### 1. Cooling Section Magnets and Power Supplies

# LEReC-I (2MeV): Gun to dump

# Revised Cooling Section

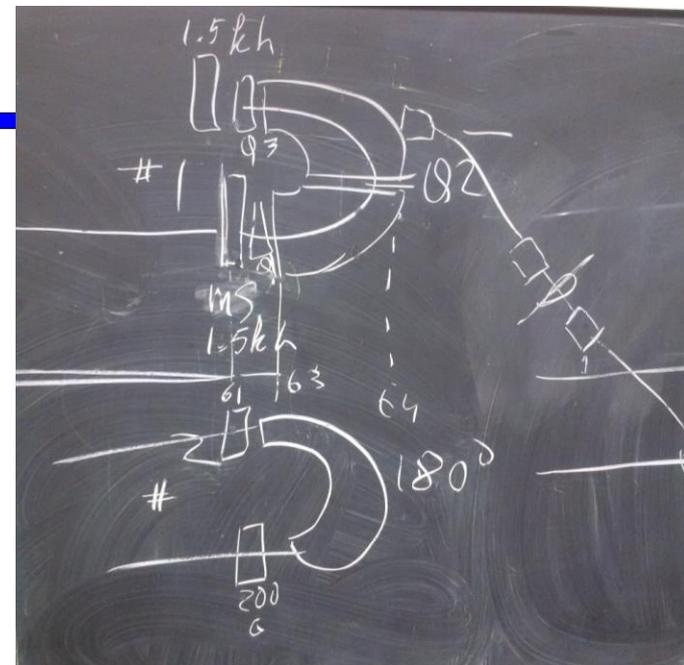
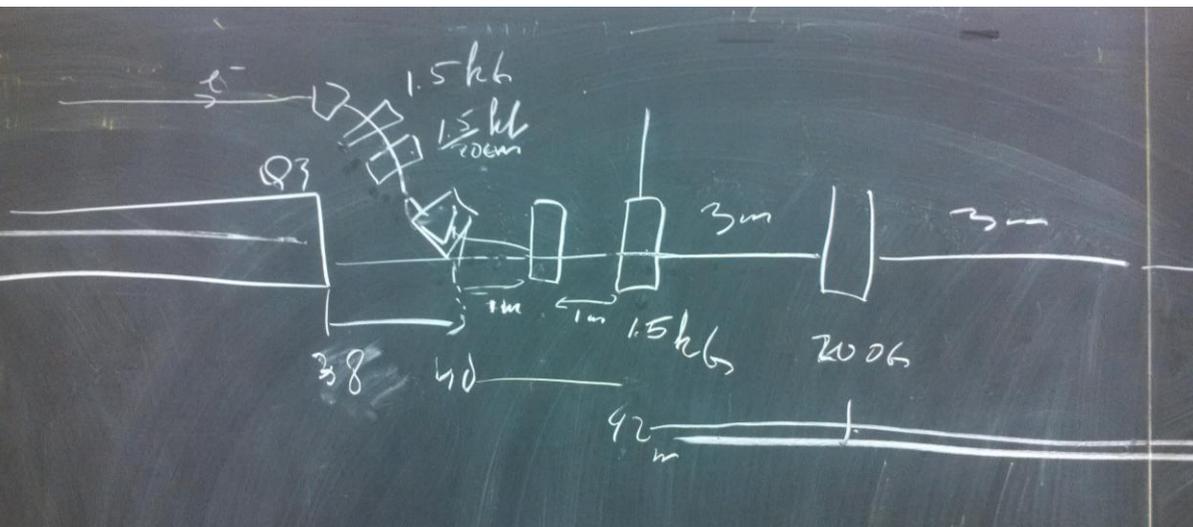
Q3 Details: valve, bellows, 10 Hz corrector, RHIC BPM, ion pump, transition chamber, survey points.

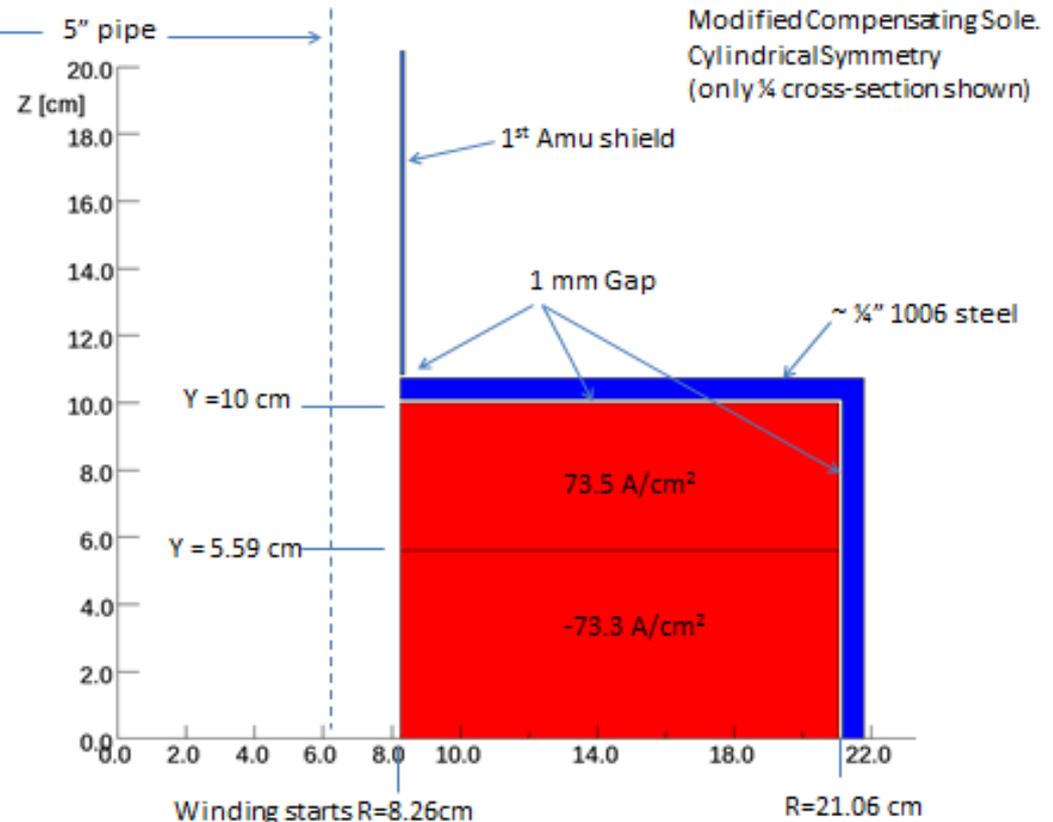
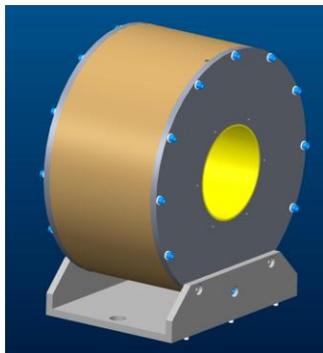
Attached files show the modified design, by mainly increasing the width (in radial direction R). Since the physical length along the Beam did not change, so that previous Horizontal/Vertical dipole correction coils design will remain the same.

From the Excel file, the  $B_z < 1$  Gauss starts at  $Z = 19.7$  cm., where cooling will be effective.

The  $B^*2$  integral meets the required value ( $4E5$  Gauss<sup>2</sup> - cm).

The  $B_z$  integral is much more than 2000 Gauss-cm.

Please comment.

## Matching Solenoid w/corrector

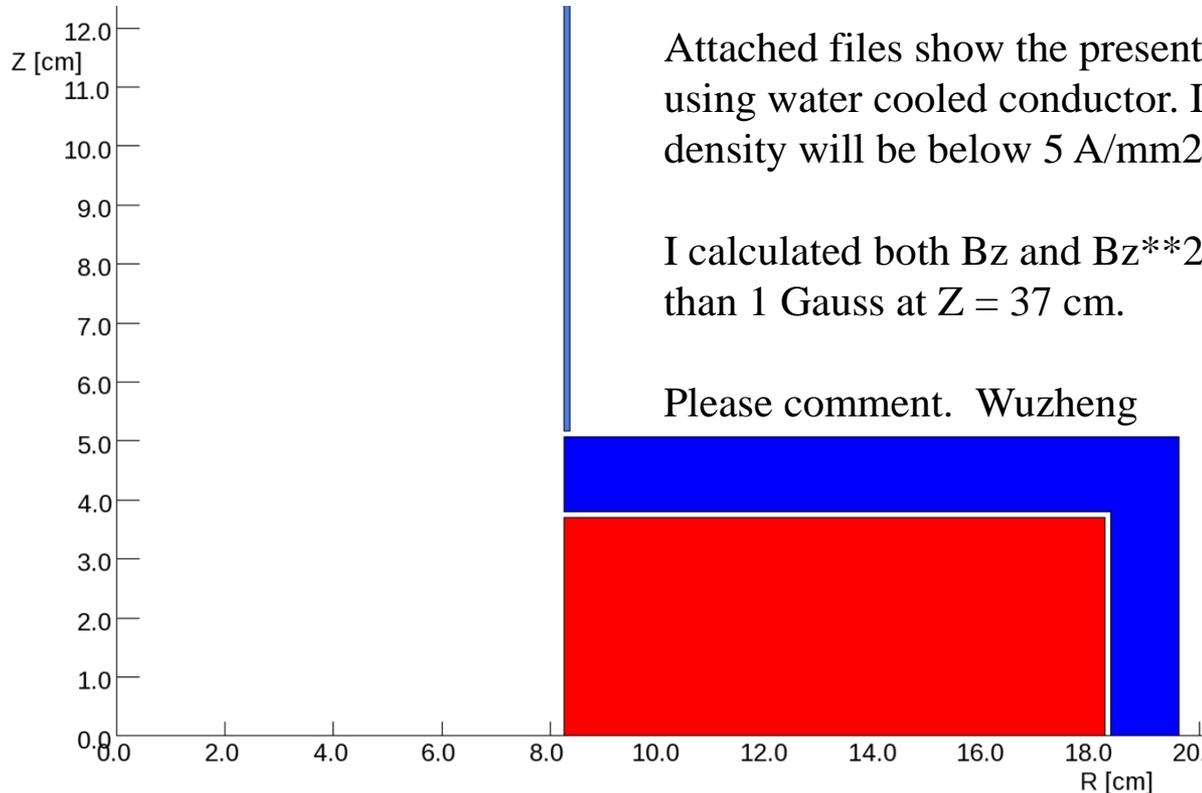
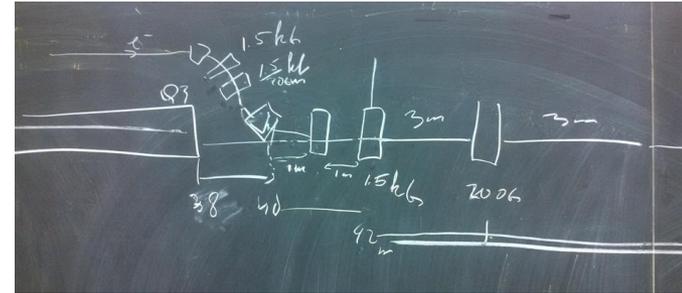
- 1.5 kG, magnetic length??
- Water cooled
- 2 required in cooling section w/o bucking coil
- Corrector 100 Gcm, present specification.

DESCRIPTION: **MOVIE LEAK CHECK GROOVES TO 1.33 CF**

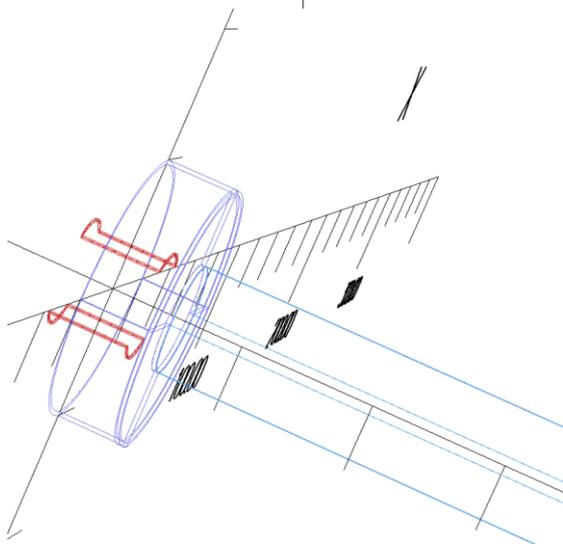
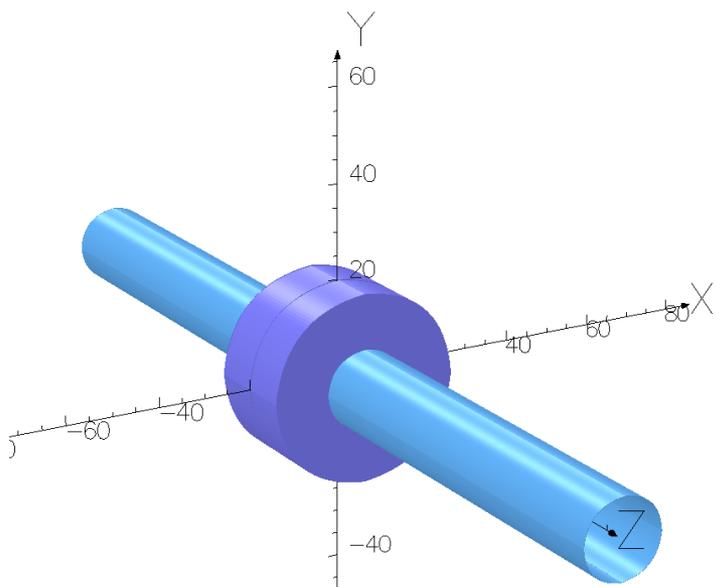
- Phone conference with MPF
- Larger diameter buttons on pick-up – 27 to 30 mm diameter
- Machined vacuum chamber, 304L, no threaded holes on flanges.
- Button hole size TBD microwave studio (D. Gassner).

# Compensating Solenoid Corrector

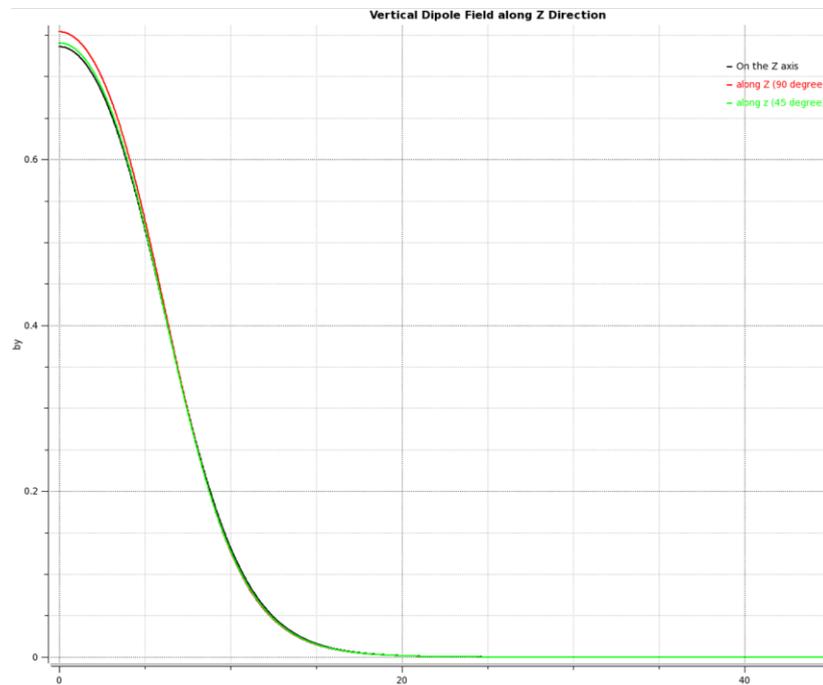
Dipole correction 10.24 A-T  
Per coil; Straight section  
Half-length:  $H1=6$  cm  
13 turns/.8 amps = 1 amp PS  
(AWG #18 = 0.98 A/mm<sup>2</sup>)
